Abnormal Chirp or Squeak Noise From High Pressure Fuel Pump

Service Category Engine/Hybrid System

Section Fuel System

Figure 1.

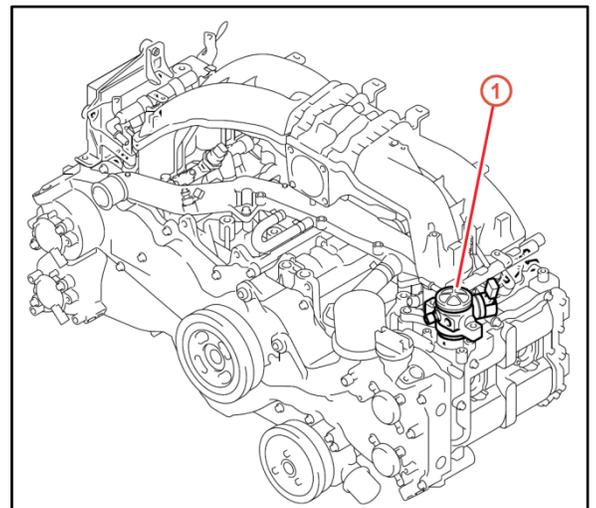
1. Road test the vehicle for at least 10 minutes so that the engine is fully warmed-up.
2. While the engine is idling, listen for abnormal noise from the high pressure Fuel Pump Assembly.

- A mechanical ticking noise from the high pressure Fuel Pump Assembly is normal during direct injection system operation.
- This bulletin should **ONLY** be performed if an abnormal high pitch chirp or squeak noise from the high pressure Fuel Pump is verified.

4. Replace the high pressure Fuel Pump Assembly.
